# AP1000 DESIGN CERTIFICATION REVIEW

## Response to Request For Additional Information

RAI Number: 720.087

RAI Number: 720.088

Figure 39A-2 Core Shroud

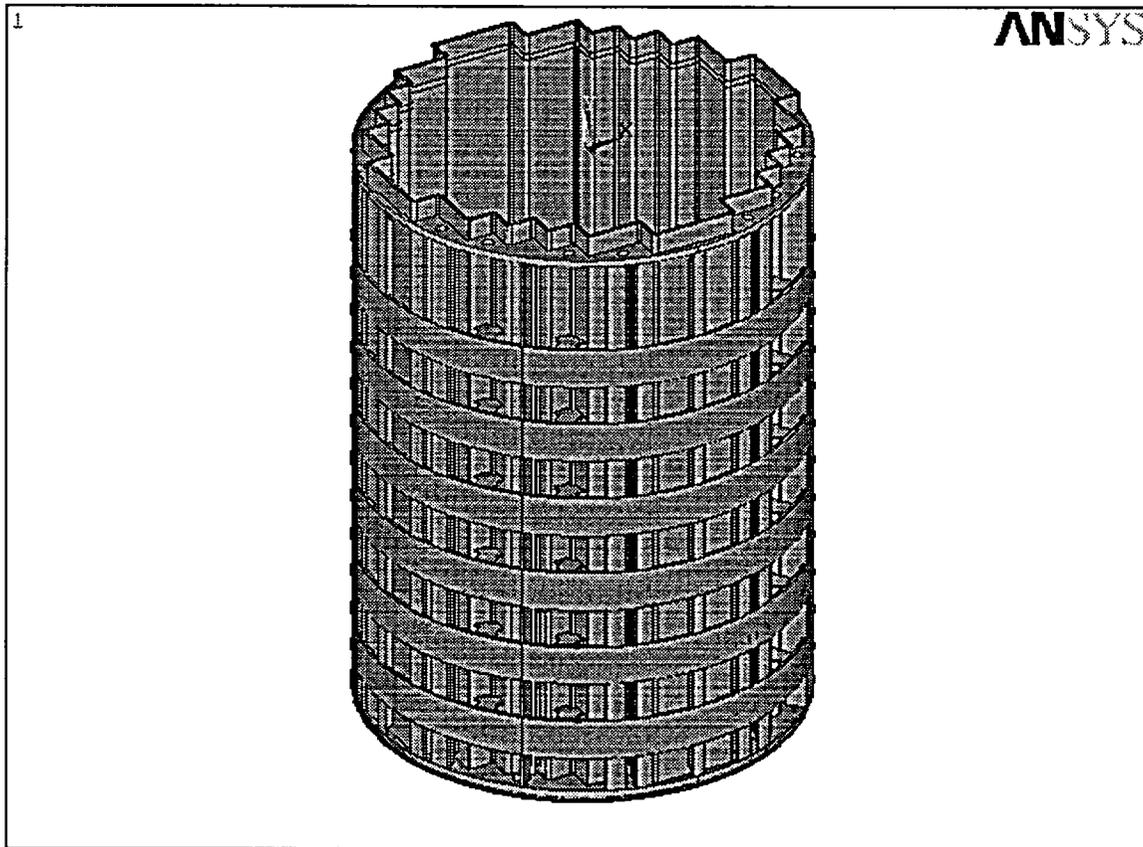
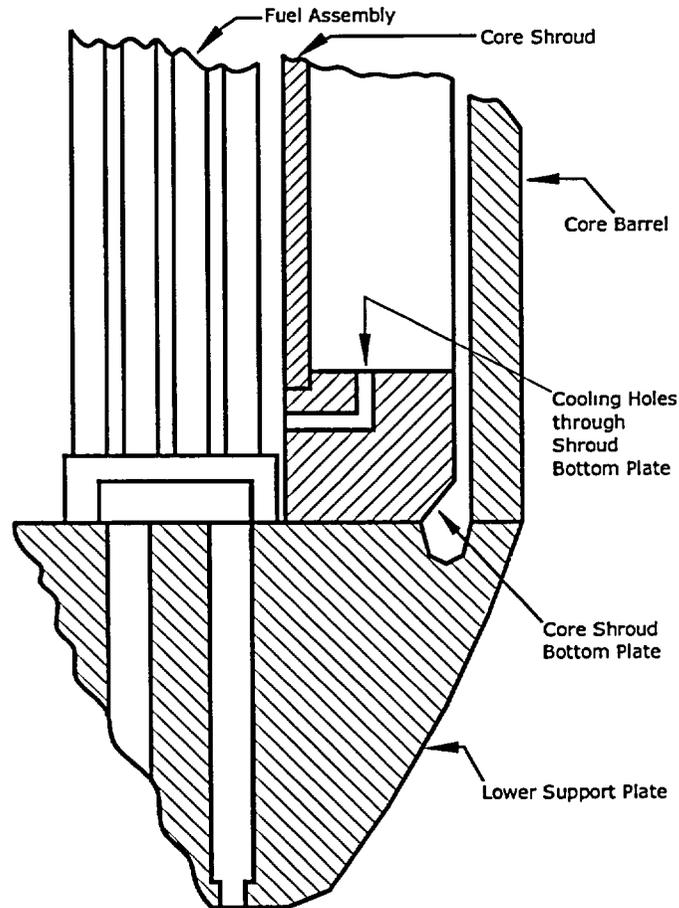
In order to resolve the issue of in-vessel debris coolability due to lower head cooling for the AP1000, Westinghouse refers to a previous U. S. Department of Energy (DOE) study of the same issue for the AP600 (T. G. Theofanous, et al., "In-Vessel Coolability and Retention of a Core Melt," DOE/ID-10460, October 1996), and states that these results are directly applicable to the AP1000. The following questions are relevant to the applicability of the DOE AP600 experiments and analyses to AP1000:

- C. What is the impact of the higher fuel enrichment on the melt progression and pour rates into the lower plenum?
- D. The analysis performed by Theofanous (T. G. Theofanous, et al., "In-Vessel Coolability and Retention of a Core Melt," DOE/ID-10460, October 1996) and Westinghouse, in portraying the molten pool state inside the lower head, does not consider:

- (i) The potential focusing effects of a thin metal layer on top of the molten pool (with a high thermal conductivity) on the local heat flux on the vessel wall, especially considering the results of calculations for small molten steel masses documented in the study by INEEL (J. L. Rempe, et al., "Potential for AP600 In-Vessel Retention through Ex-Vessel Flooding – Technical Evaluation Report," INEEL/EXT-97-00779, Idaho National Engineering Laboratory, December 1997).
- (ii) The potential influence of impurities in the debris bed that could result in stratification of the oxide pool into layers of different composition (as observed in the OECD RASPLAV and MASCA programs).
- (iii) The potential influence of zirconium, steel and uranium partitioning between oxide and metallic phases, on the downward heat transfer (as observed in the OECD MASCA experiments).

The core is surrounded by a 7/8-inch (2.2 cm) thick core shroud (Figure 39A-2). The shroud panels conform tightly to the outside perimeter of the core. The shroud supporting structure is comprised of a top plate and a bottom plate, six 12.5 in (32 cm) high ring assemblies spaced 12.5 in (32 cm) apart vertically and radial ribs that tie the panels to the rings. The core shroud sits inside the cylindrical core barrel. The core barrel has an inner diameter of 133.75 inches (3.4 m) and is 2 inches (5.1 cm) thick. The volume between the core barrel and the core shroud has a cross-sectional area of 1.5 m<sup>2</sup>. The lower core support plate is welded to the bottom of the core barrel and the core barrel hangs from the flange of the reactor vessel.

The MAAP4 modeling is not capable of fully modeling the complexities of the actual shroud/barrel geometry, which is not lumped, and is not a concentric cylinder around the core. The behavior of the core melting and relocation is insensitive to the heat sink modeling, but the response of the core shroud and barrel to the core melt is difficult to accurately model with the lumped cylindrical model. In the AP1000 MAAP4 model in this analysis, the core shroud/barrel heat sink was set up to conserve the total radial heat capacity and mass of the actual shroud and barrel. The mass of the core shroud panels and supporting structures in the active fuel region of the core is 17650 kg. The mass of the core barrel in the active fuel region of core is 18320 kg. Therefore, the total mass of the shroud and core barrel together provides a heat sink mass of 35970, or 2400 kg per each of the 15 axial rows of nodes in the active core model. The inside radius of the heat sink model is set to be 1.648 m (ID = 129.75 inches). The actual inside radius is 133.75 inches. The modeled radius maintains the outer radius of the core barrel (OD = 137.75 in), but makes the total thickness of the heat sink 4 inches. The increased thickness over the actual total thickness of 2.875 inches increases the thermal resistance of the heat sink model due to thermal conductivity, however it cannot completely account for the total thermal resistance due to the radiation heat transfer between the shroud panel and the core barrel.
